APPENDIX E

RESPONSES TO COMMENTS ON THE DRAFT EA/IS

Responses to comments that were received during the 30-day public comment period on the Draft Environmental Assessment/Initial Study (EA/IS) for the Fresno County Service Area (CSA) 34 Winchell Cove Pipeline Project (Proposed Project) from July 8th to August 8th, 2011 are provided below. The three comment letters received are indexed in **Table 1**. The comment letters, which have been bracketed and numbered for ease of reference, are presented immediately after the responses.

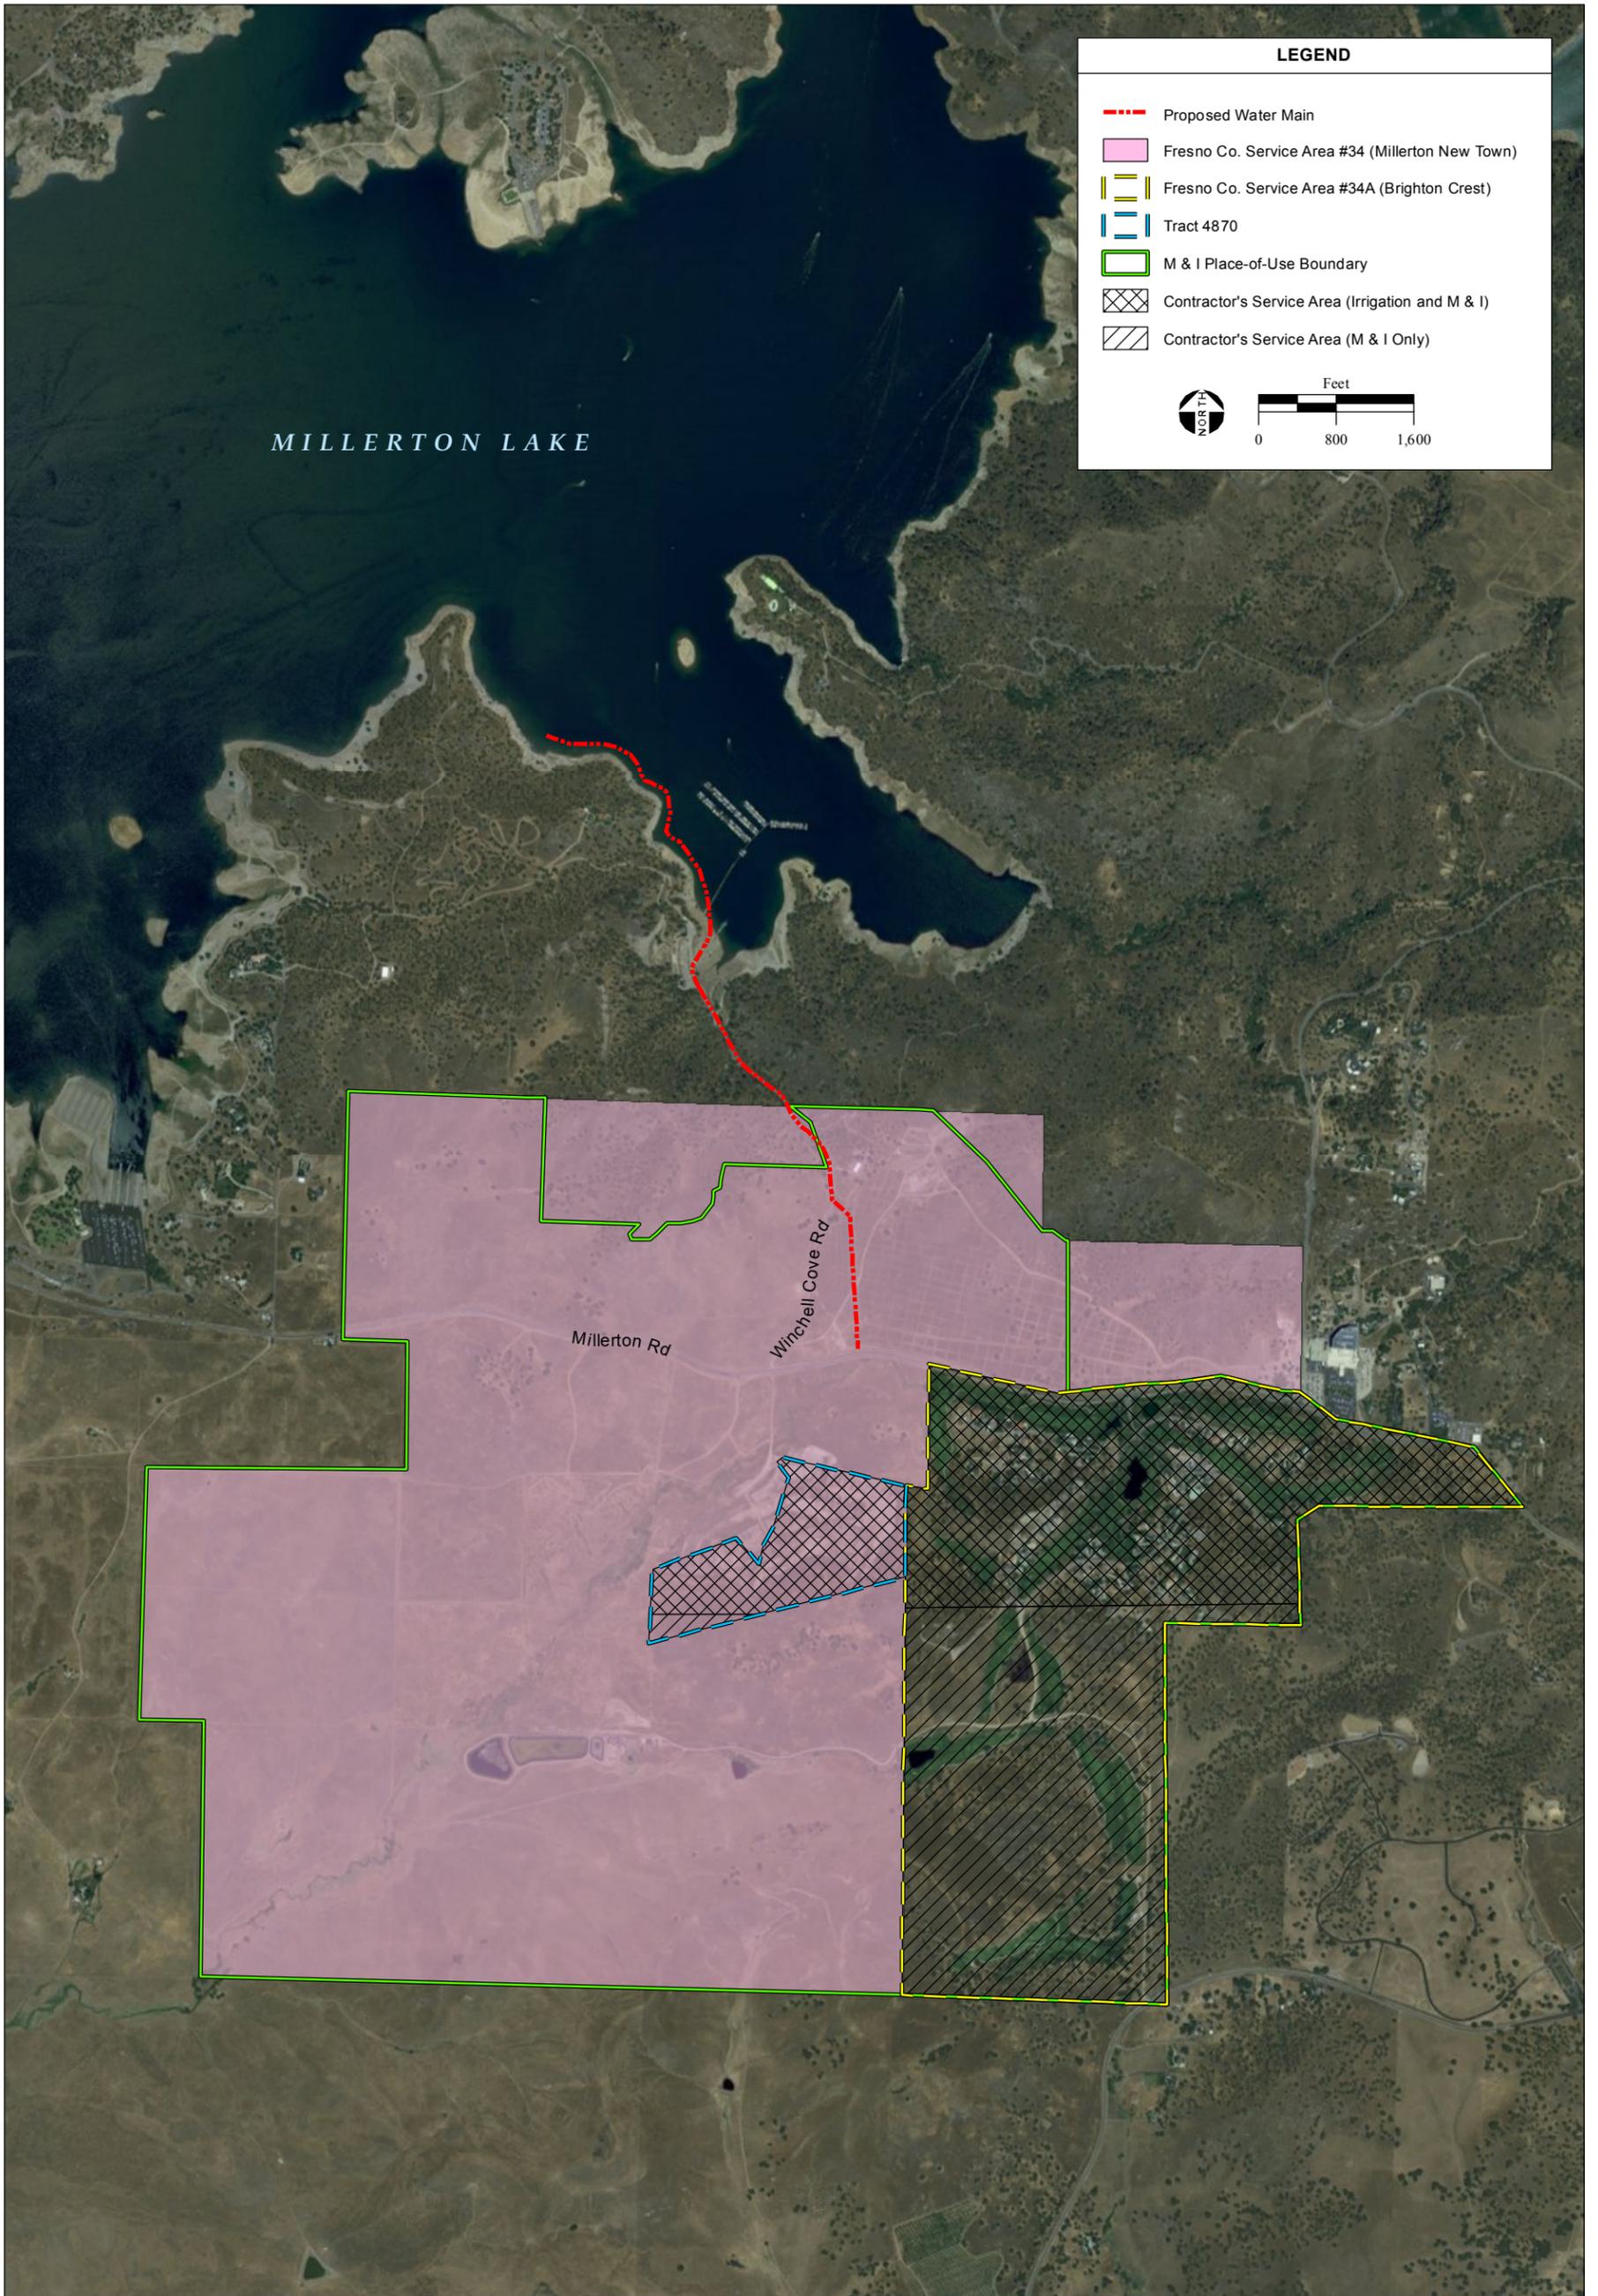
Summary of Comments: Several comments noted that there are a number of development projects in the vicinity that could be served by the Proposed Project and requested that the analysis within the EA/IS be expanded to consider full build-out of developments that may be provided water through the proposed pipeline and CSA 34 infrastructure.

The CSA 34 boundary consists of approximately 1,903 acres and includes the Millerton New Town Specific Plan Area and Brighton Crest. The delivery of Central Valley Project (CVP) water from Millerton Lake through the Winchell Cove Pipeline is subject to an existing contract between Reclamation and CSA 34 (Contract No. 14-06-200-8292A). The contract service area for municipal and industrial use of water delivered through the Winchell Cove Pipeline is limited to Brighton Crest, and was recently expanded to include an 83-acre area within Millerton New

Town referred to as “Tract 4870”. The existing boundaries of CSA 34 and the authorized contract service area for delivery of water are shown in **Figure 1** of this Response to Comments. As stated in a March 8, 2010 letter from Reclamation to the County:
